ACCESS PERMIT APPLICATION

Permit # AC 2023-01
Parcel ID: 06746

Description of Project: widen 746 Dugway driveway to separate and distinguish it from next door neighbor's new Private road. Is property in floodplain? no

To: Richmond Selectboard
From: Peter Gosselin, Road Foreman 
cc: Josh Arneson, Town Manager
Date: 4-5-23
Re: Access permit for 746 Dugway Road

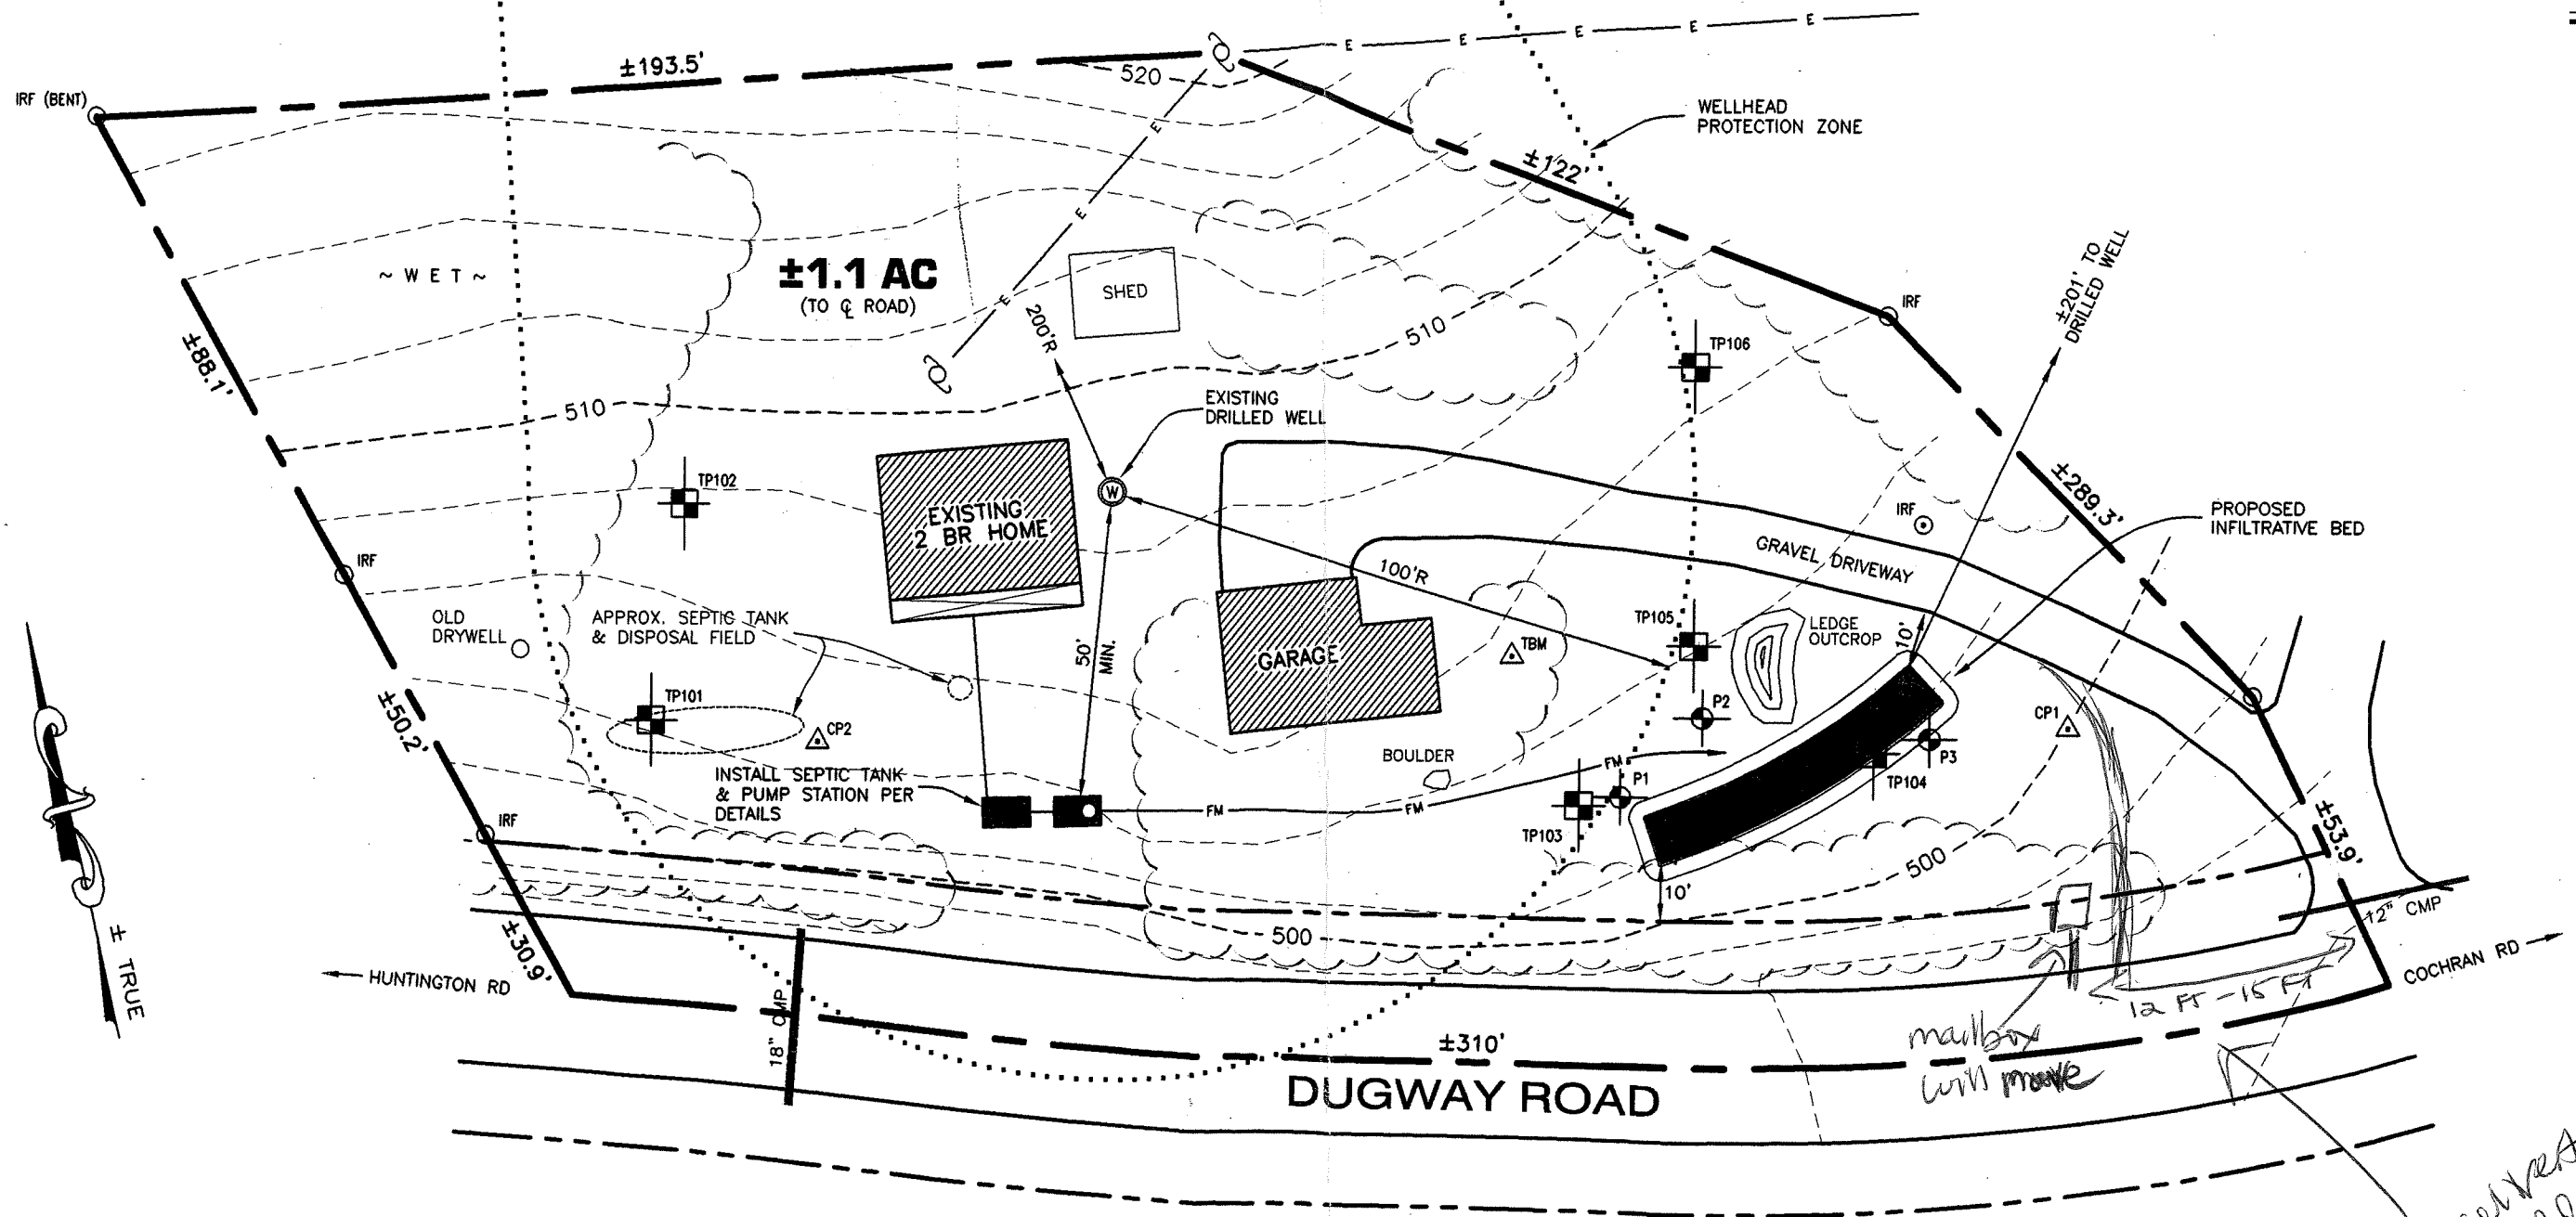
The fact that this shared access predated the change to a private road, there are no specifications for changing it. Ultimately E911, Richmond Highway and Richmond Zoning are in favor of widening the entrance to delineate 746 from the private road.
